# Access Compliance Report

## Public Rights-of-Way

### (Curb Ramps)

Intersection ID: 29275	Main Street: CHALK_HILL_LN	Cross Street: PAWLEY_DR	Location: SW
ADA ID: 8F7687B8E491	Ramp Type: Perpendicular Diagonal	Initial Pass/Fail: Fail	Overall Compliance: No
		Severity Score: 12.5

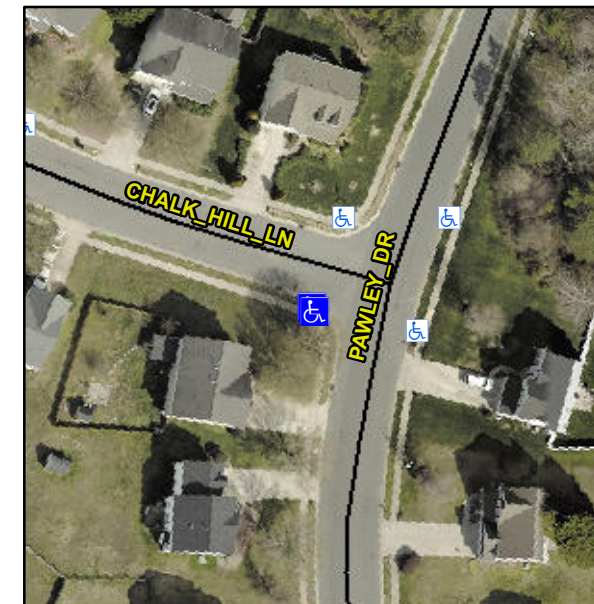
**Not Found, R304.2.2**

Compliance	Description	Data	Compliance	Description	Data
N/A	Ramp Length (in)	45.0	No	Ramp Slope (%)	11.2
Yes	Ramp Width (in)	48.0	Yes	Ramp XSlope (%)	0.4
N/A	Flare Type LT	N/A	N/A	Flare Type RT	N/A
N/A	Flare Slope LT (%)	N/A	N/A	Flare Slope RT (%)	N/A
N/A	Flare Traversable LT?	N/A	N/A	Flare Traversable RT?	N/A
N/A	Landing Length (in)	N/A	N/A	DWS Provided?	N/A
N/A	Landing Width (in)	N/A	N/A	DWS Contrast?	N/A
N/A	Landing Slope (%)	N/A	N/A	DWS Length (in)	N/A
N/A	Landing X Slope (%)	N/A	N/A	DWS Full Width?	N/A
N/A	Landing Curb? (Y/N)	N/A	N/A	DWS Offset (in)	N/A
N/A	Shared Landing?	N/A			
N/A	Gutter Ponding?	N/A	N/A	Gutter Slope (%)	N/A
N/A	Gutter Lip Ht (in)	N/A	N/A	Gutter X Slope (%)	N/A
N/A	Painted X Walk1?	No	N/A	Painted X Walk2?	No
	X Walk 1 Direction	To E		X Walk 2 Direction	To N
N/A	X Walk 1 Width (in)	N/A	N/A	X Walk 2 Width (in)	N/A
	X Walk 1 Slope (%)	1.7		X Walk 2 Slope (%)	3.8
	X Walk 1 X Slope (%)	4.5		X Walk 2 X Slope (%)	1.5

**Remove & Replace Curb Ramp With Two New Directional Ramps or Equivalent.**
